MILLSTONE NUCLEAR POWER STATION, UNIT NO. 2

AMENDMENT TO FACILITY OPERATING LICENSE

Amendment No. 23  
License No. DPR-65

SAFETY EVALUATION BY THE OFFICE OF NUCLEAR REACTOR REGULATION  
SUPPORTING AMENDMENT NO. 23 TO FACILITY OPERATING LICENSE NO. DPR-65  
NORTHEAST NUCLEAR ENERGY COMPANY  
MILLSTONE NUCLEAR POWER STATION, UNIT NO. 2  
DOCKET NO. 50-336

Figure 3.2-1 Allowable Peak Linear Heat Rate vs Burnup

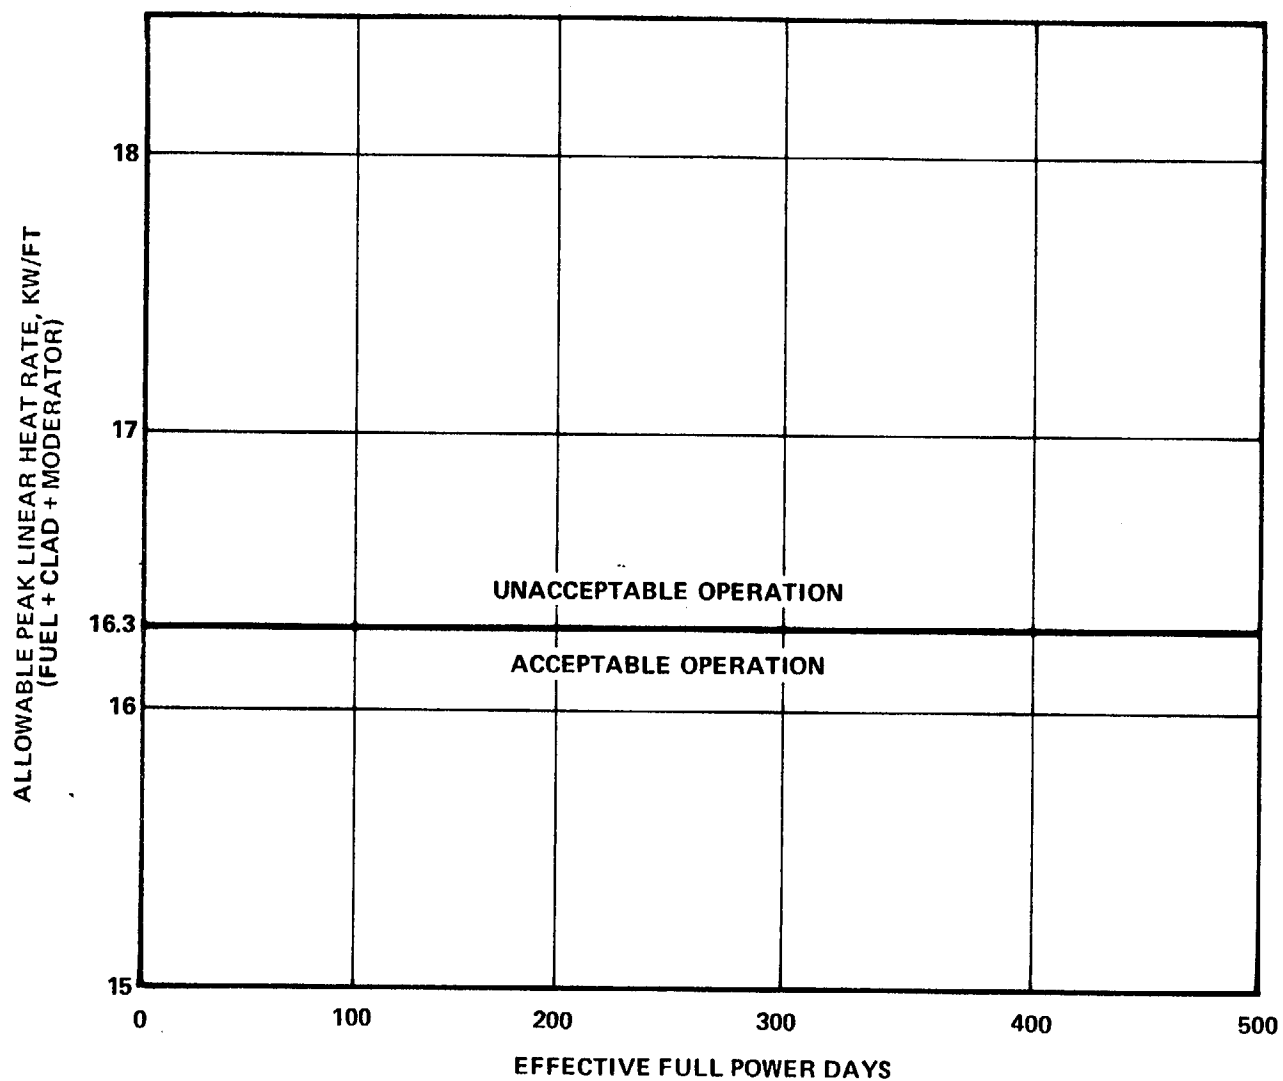
This amendment terminates the 14.1 kw/ft limit on PLHGR as stated in our Order for Modification of License issued June 17, 1976 and also increases the PLHGR from 14.1 kw/ft to 16.3 kw/ft.

Replace the following page of the Appendix "A" Technical Specifications with the enclosed page. The revised page is identified by Amendment number and contains vertical lines indicating the area of change. The corresponding overleaf page 3/4 2-4 is also provided to maintain document completeness. No changes were made on 3/4 2-4.

As a result of our evaluation as described in the above sections, we conclude that the Millstone Unit No. 2 ECCS performance with reactor operation at a PLHGR of 16.3 kw/ft will conform to the peak clad temperature, maximum oxidation, hydrogen generation, coolable geometry and long term cooling criteria of 10 CFR Part 50, Section 50.46(b) and is therefore acceptable. Thus, the proposed change in Millstone Unit No. 2 Technical Specification 4.2.1.3.b., which increases the PLHGR from 15.3 to 16.3 kw/ft, is acceptable.
